**DEVIATION REQUEST  
AND DECISION FORM IN  
ASSOCIATION WITH A  
REQUEST FOR A PUD  
MODIFICATION FROM  
THE ECM**

A deviation from the standards of or in Section **ECM2.2.4.B.7 (Figure 2-17), Table 2-7, ECM 2.3.3.F.3 and standard detail SD\_2-2** of the Engineering Criteria Manual (ECM) is requested.

**WATERSIDE TOWNHOMES**  
 DEVIATION REQUEST - ECM SEC. 2.2.4.B.7.  
 FIGURE 2-17, TABLE 2-7  
 PCD FILE NO. PUDSP-22-009

**PROPOSED TYPICAL SECTION – PRIVATE ROADWAY TRACT**

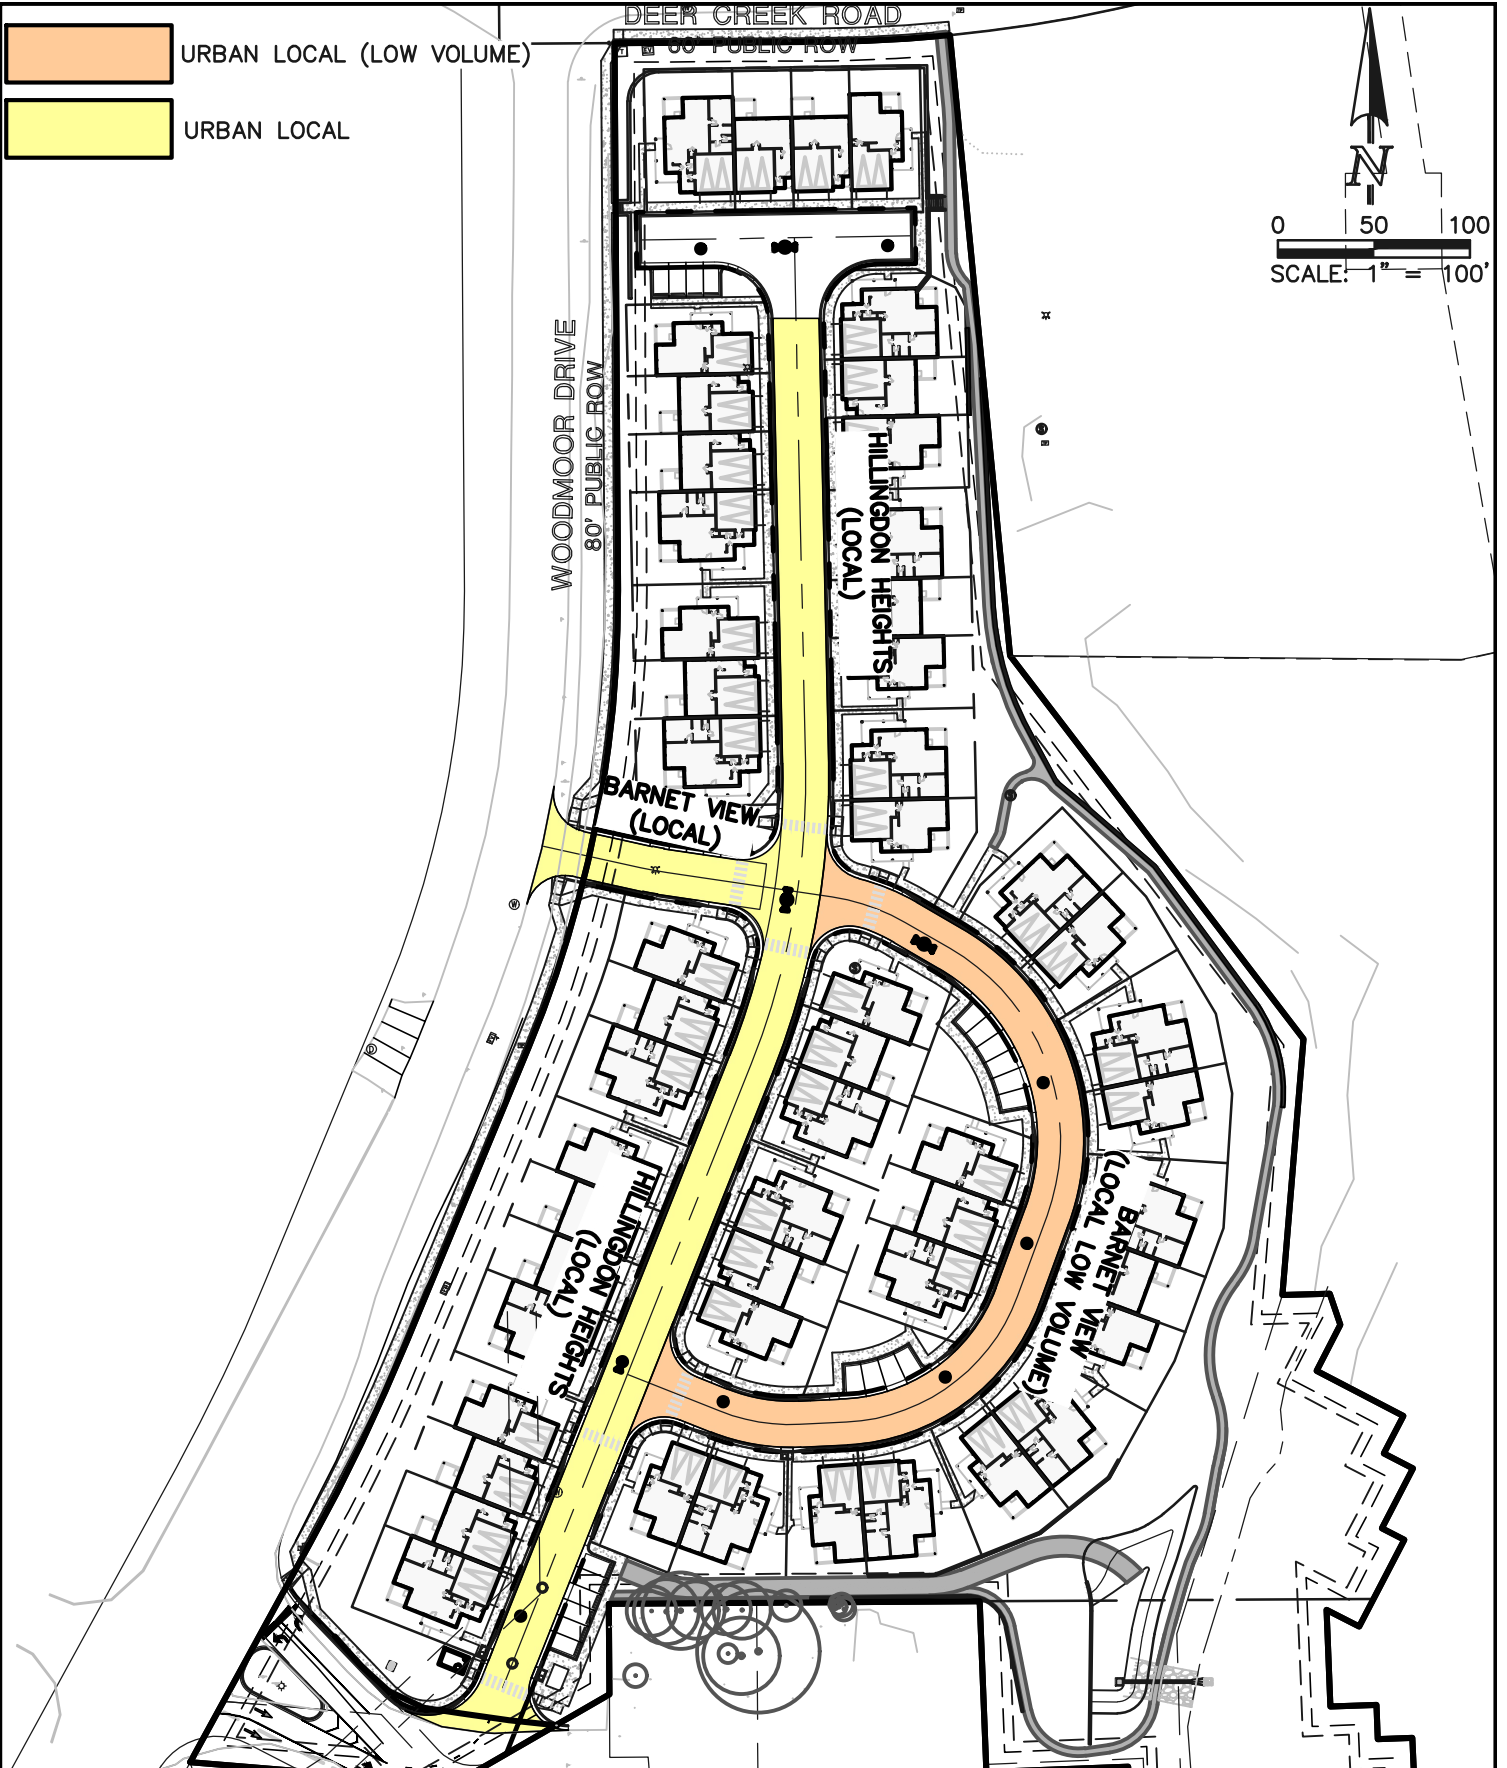
Delete highlighted statement
